| Project Title: | Fountain Wind Project |
| Document Title: | Jim Wiegand Comments - Against Fountain Wind #9 |

Jim Wiegand Comments - Comments Against Fountain Wind #9

Comments on the Fountain Wind Project Draft Environmental Impact Report

Turbine site locations and critical habitat avoided in DEIR research.

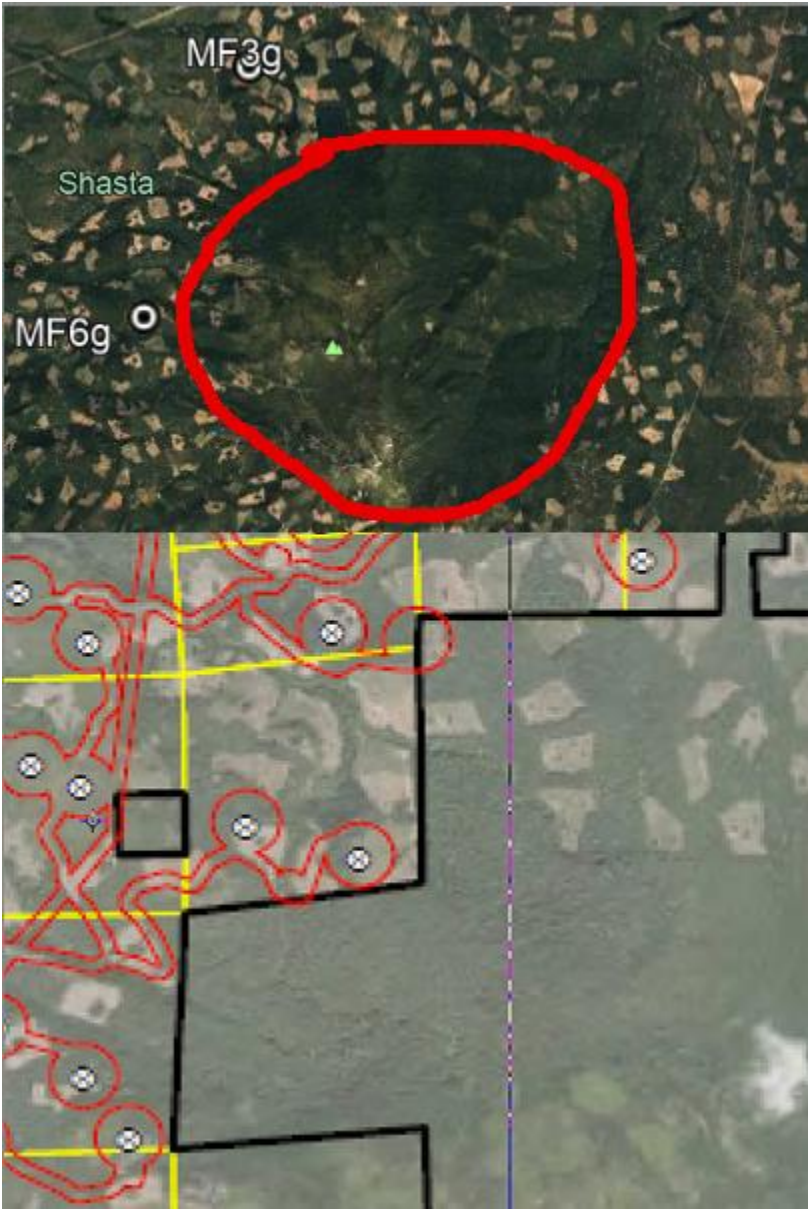
No Goshawk nesting or nesting territories were reported in the DEIR. This information tells me otherwise. But DEIR studies were deliberately **created to avoid** the most favorable habitat. Habitat well with the mortality footprint of both wind projects. There could be active nests 100 yards from turbine sites near MF3g and MF6g. But if research avoids looking, the public would never know.

Figure 3.4-4
Spotted Owl Territories in the
Hatchet Ridge Wind Project Region

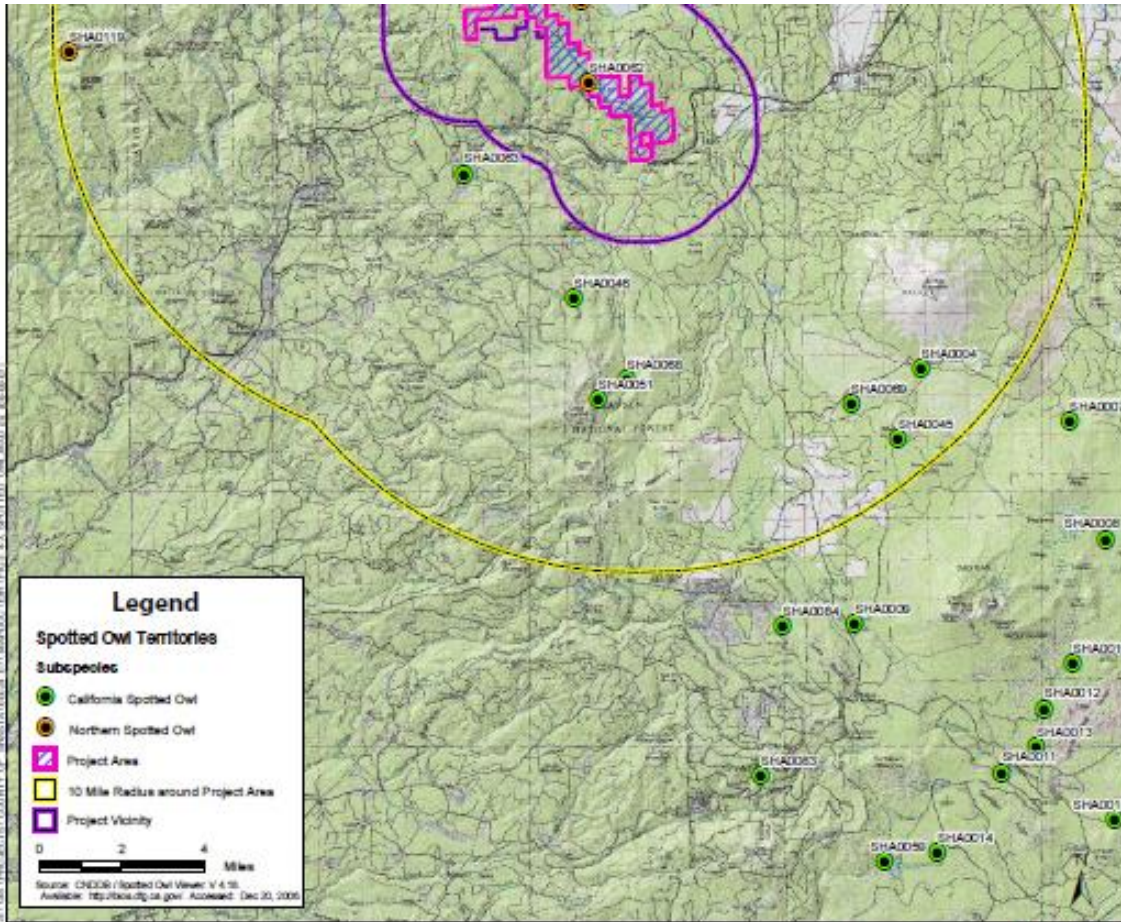
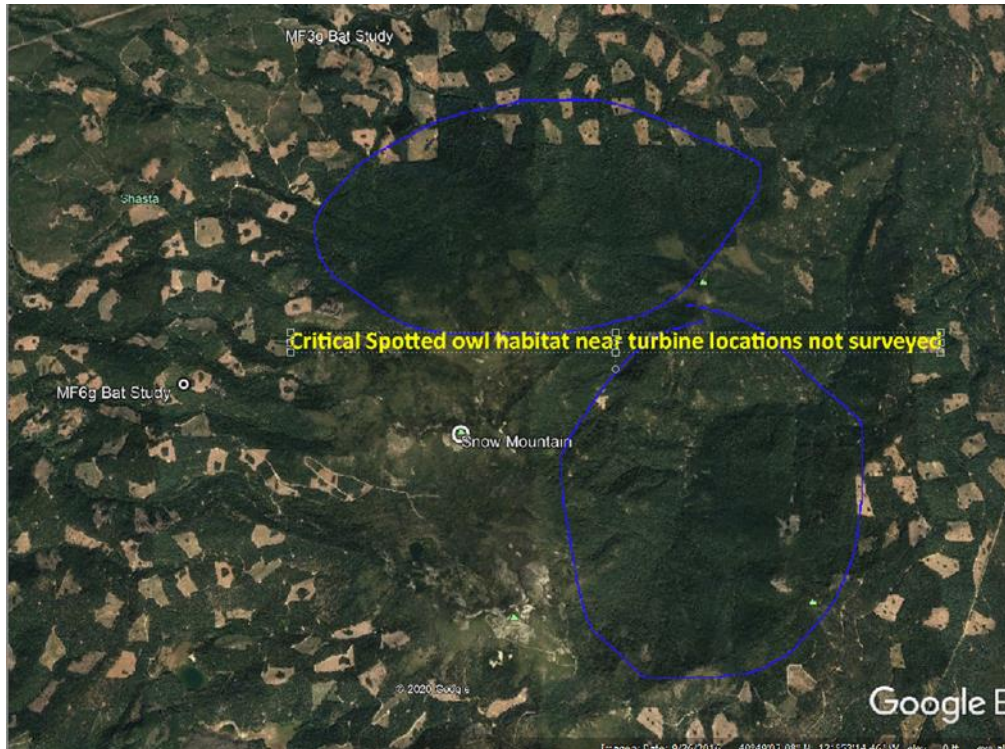
Besides the Fountain fire burning some of this owl habitat, what has happened to all these spotted owl nesting territories reported in the Hatchet Ridge EIR?

The Fountain Wind DEIR does not say

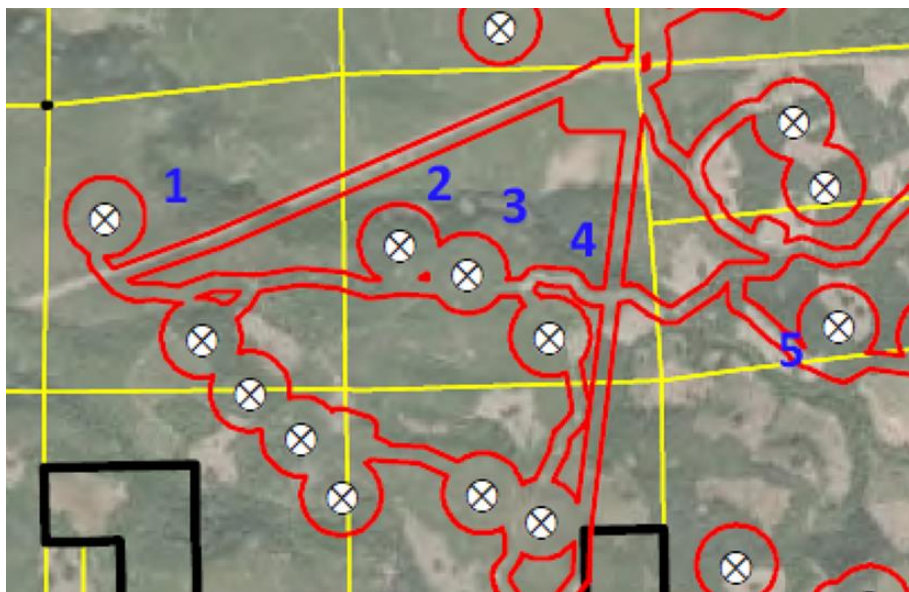
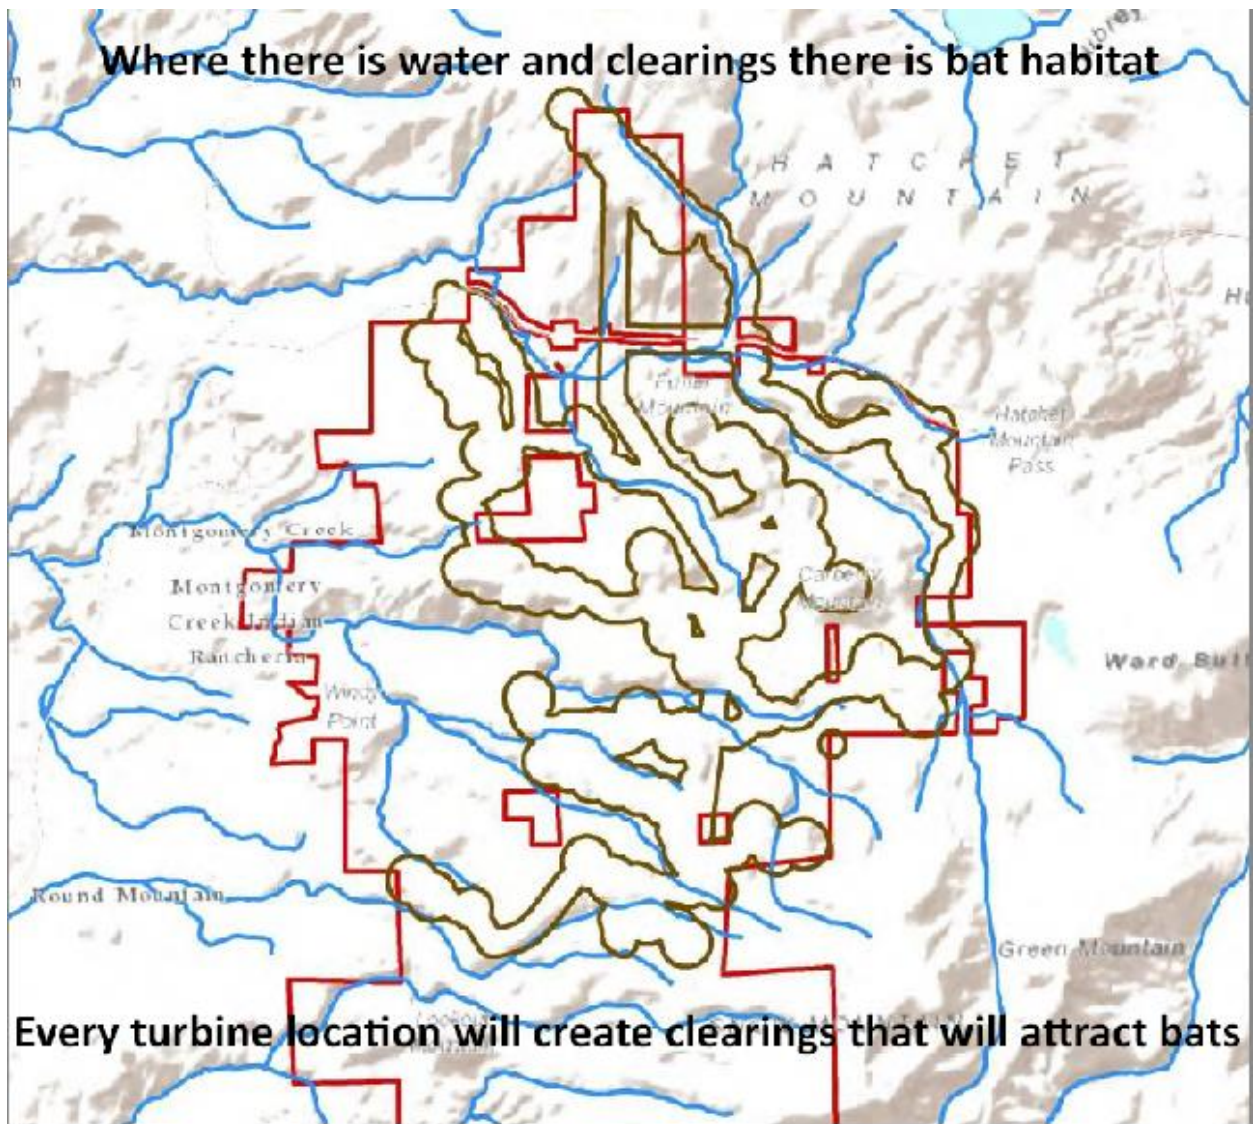
Not True - Five massive turbines will be located along this creek location (see image).

If the Bat Acoustic survey had positioned all their equipment in open areas near water with clearings, the total bat passes in this survey would have easily been several hundred thousand. The MF3g site shows this. Wind Biologists also know this and when bat surveys are conducted, they try to locate equipment away from the best bat feeding locations. I have examples that show this research pattern in other studies. Of course, the bats living near MF3g will be annihilated by at least 5 of the Fountain Wind turbines, that will be locate along this creek site.

Figure 2. Eagle and other raptor nest locations documented during aerial surveys for the Fountain Wind Project, March 20 and May 9, 2017.

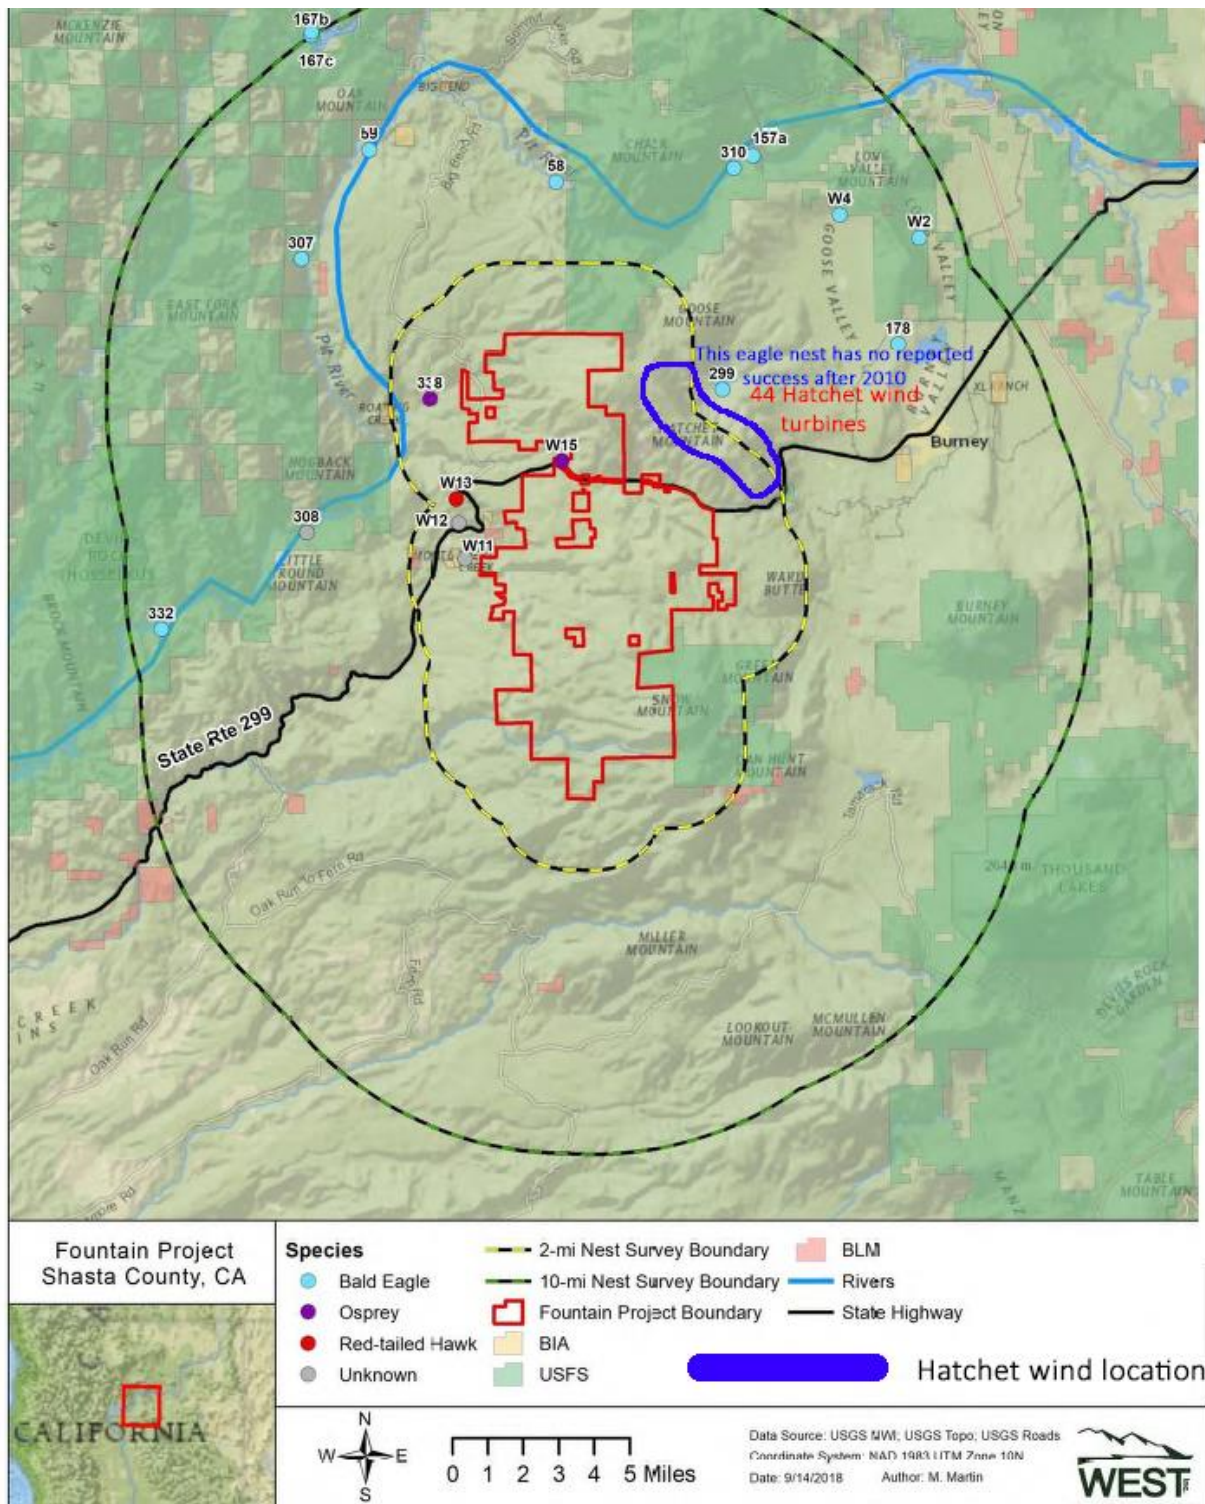
Now, 10 years after the Hatchet Ridge wind turbines started spinning, the Fountain Wind DEIR reported one occupied raptor nest, within 5 miles of these turbines with no credible explanations. Since 2010 bald eagles attempting to

nest at Margaret lake, are very likely being killed off every year.

Figure 7. Locations of raptor nests within two miles of Hatchet Ridge.

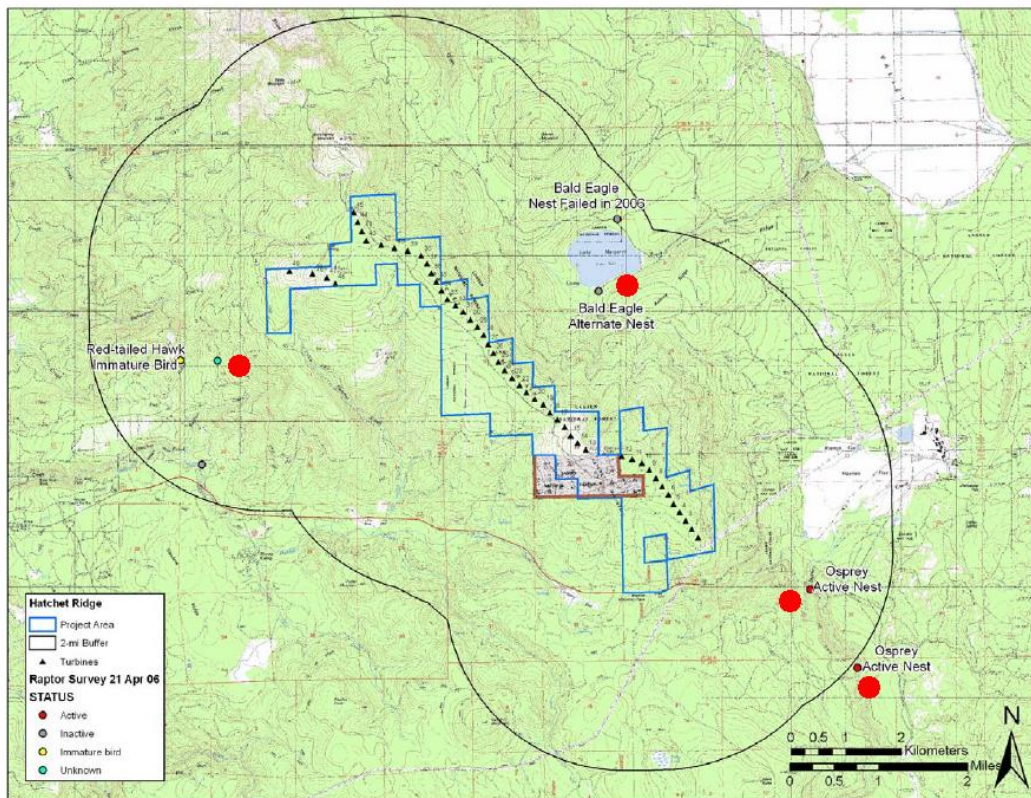
What has happened to these nesting territories since 2010 after 44 Hatchet ridge turbines became operational ???
